**DESIGN/PROCESS CHANGE NOTIFICATION**

MB10S	MB1S	MB2S
MB4S	MB6S	MB8S

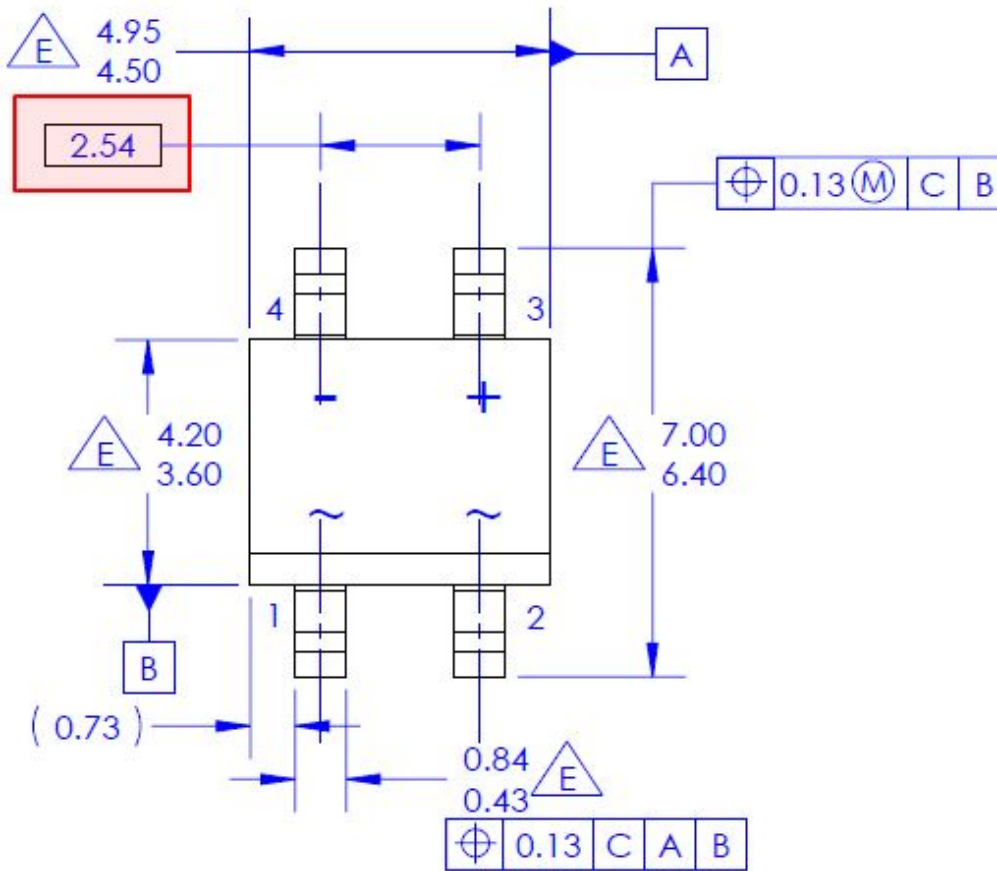
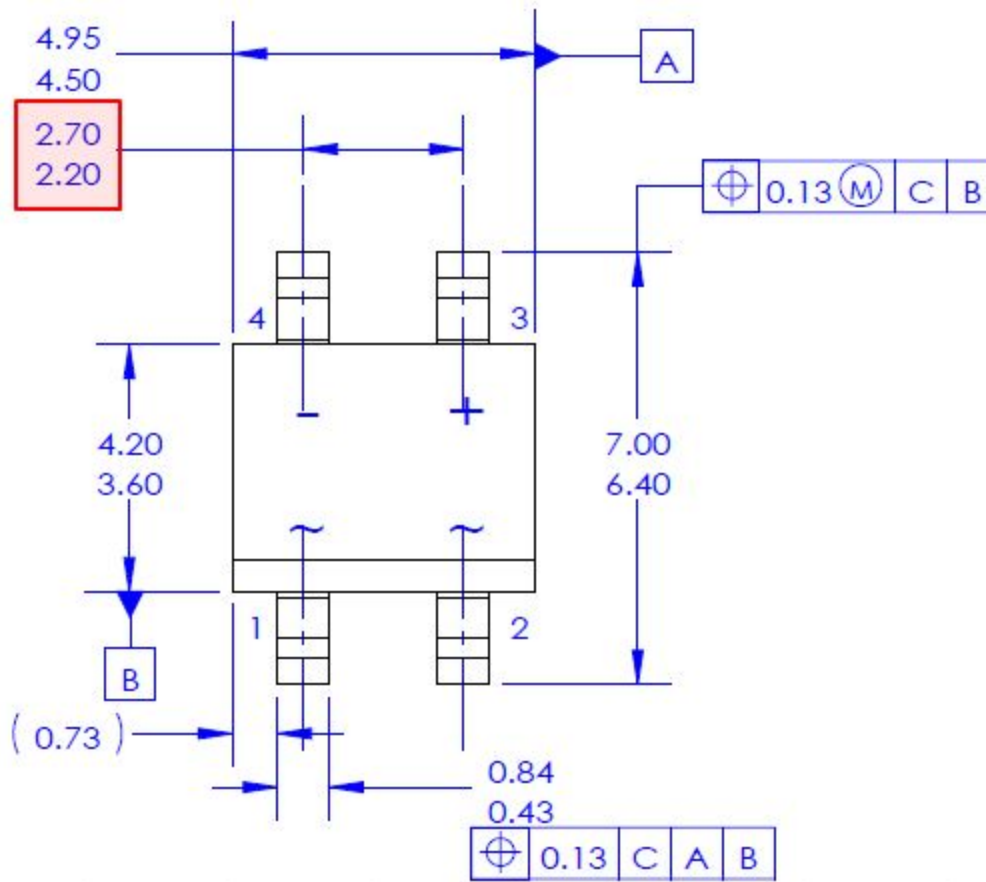
Description of Change (From) :  
Package Lead pitch: 2.54mm typical  
(with an implied tolerance of +/-0.13 = 2.41mm min to 2.67 max)

Description of Change (To) :

Reason for Change:  
In order to indicate the min & max tolerance for lead pitch.

Package Lead pitch: 2.2mm min to 2.7mm max
